SAXTON NUCLEAR EXPERIMENTAL CORPORATION

Subject: Saxton Nuclear Experimental Corporation
Operating License No. DPR-4
Docket No. 50-146
Response to the NRC Request for Additional Information
Regarding Technical Specification Change Request No. 55

Operating License No. DPR-4
Docket No. 50-146
Technical Specification Change Request No. 55

Figure 1
Saxton Nuclear Facility Layout

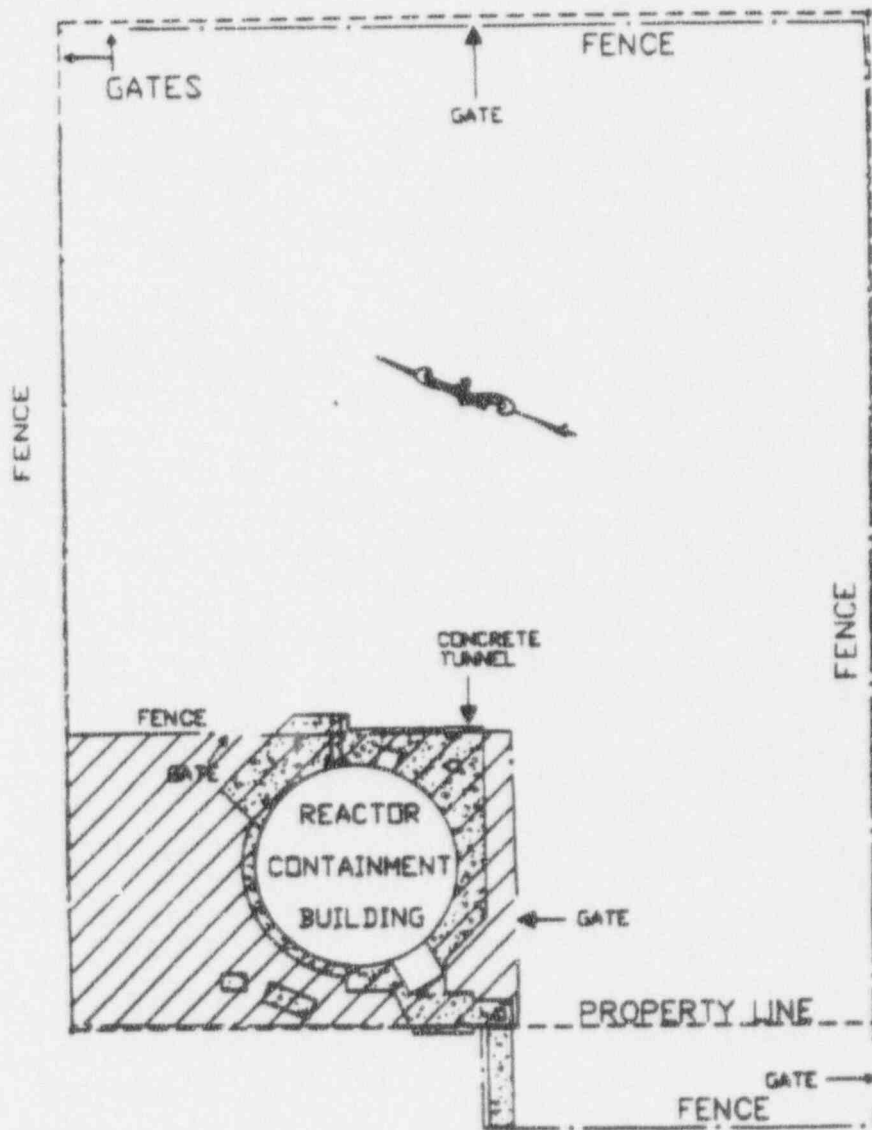
- a. The exclusion area consists of that portion of the Saxton Nuclear Experimental Corporation property enclosed within the fence containing the Containment Vessel. See Figure 1.
